8.1 DA0125/2021 - 18 Marshfield Lane, Mudgee - Torrens Title Subdivision of Land (1 into 24 Lots)

REPORT BY THE PLANNING COORDINATOR
TO 15 SEPTEMBER 2021 ORDINARY MEETING
GOV400088, DA0125/2021

MWRC – DEVELOPMENT APPLICATION REFERRAL
ENGINEERING COMMENTS AND CONDITIONS

Figure 3: Mudgee Flood Study 2021 Mapping

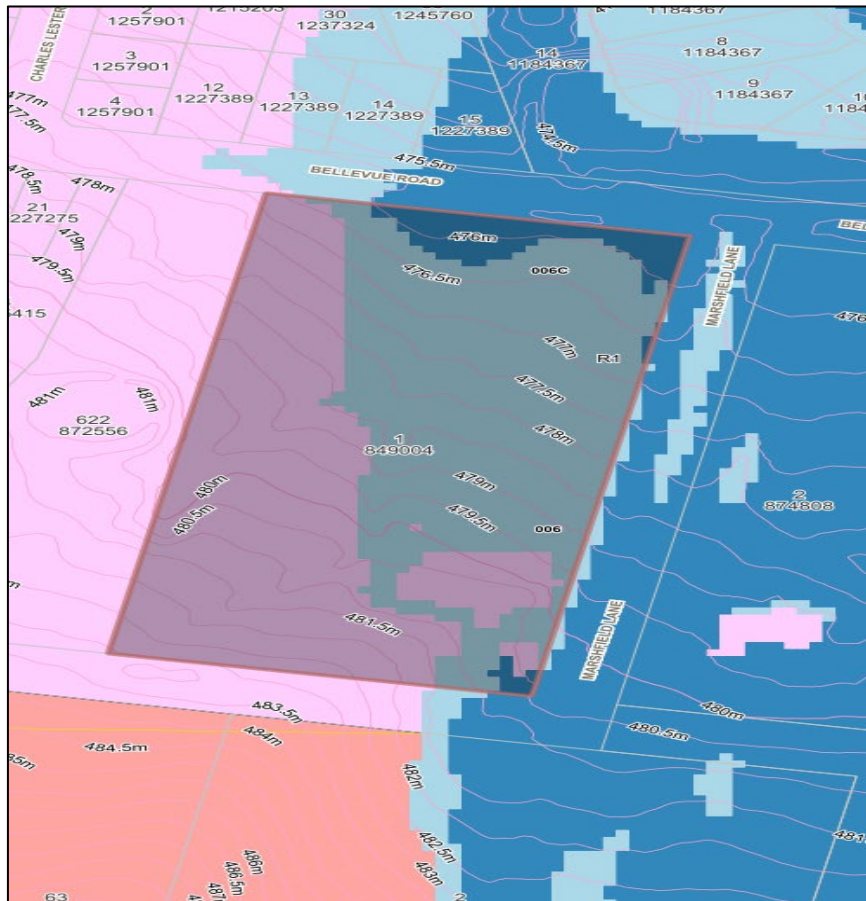
In considering any newly identified flood risks associated with the development, the subject site is identified to have small areas affected by 'Overland Flows' (dark blue area), with additional portions also affected by a Probable Maximum Flood (light blue area) i.e., greater than a 1:100 year ARI (Average Recurrence Interval) storm event in accordance with the Mudgee Flood Study 2021. Refer to the Figure 3 map below. This is based on the current arrangements and natural ground levels found across the site.

A concept cut and fill plan, provided as part of a further information request response, indicates that proposed site works to support the development includes some lot filling up to 650mm, with new stormwater drainage infrastructure proposed to direct stormwater from the site, to the existing large drainage reserve located to the north, off Bellevue Road which has capacity to cater for the proposed development.

The development has also been assessed by Council's Development Engineers which has confirmed that the proposed lot filling and drainage works will provide additional protection to the proposed lots and will formalise and control of surface water runoff in the locality. Conditions of

consent have however been recommended to ensure that the appropriate design, as part of any future Subdivision Works Certificate application, is provided to mitigate stormwater impacts on the development site and surrounding land.

Figure 1 Distance of the proposed lots from land zoned for recreational purposes applying a 400m (light green) and 440m (yellow) buffer.

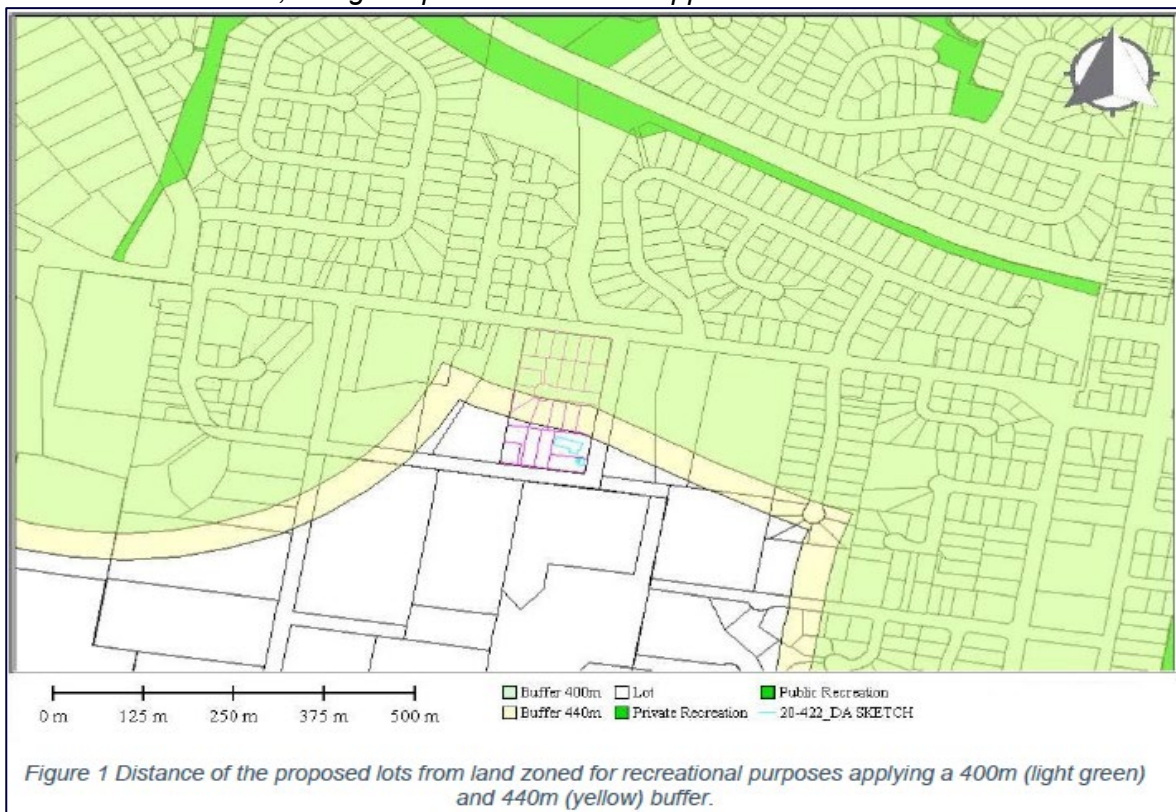
Figure 1 identifies 12 lots within 400m of a passive open space and 6 lots within 440m (applying a 10% deviation to the standard). The remaining 6 lots are outside the radius applied. The lot most distant from the RE1 zoned land is 475m (lot 24), which represents a

To provide a new 'neighbourhood park' or 'pocket park' to service this subdivision, particularly for only those 12 new lots that do not achieve full compliance in this instance with the 400m requirement is not considered to be a sustainable outcome for Council nor achieve a positive benefit for the community. As a result, the proposed variation of 18.75% is supported by Staff.

Based on a merits based assessment of this proposal, the applicants justification, and the inclusion of the need to capture developer contributions for 'recreation and open space' under the Mid-Western Regional Developer Contributions Plan 2019 at a current rate of \$2,199 per new lot, it is considered that the need to include a separate *local park, playground or passive open space* within the subject subdivision development to service those 12 lots found between 440m and 475m from the existing northern recreational areas is not considered to be an acceptable outcome to benefit the community, and the variation in this instance is recommended to be supported.
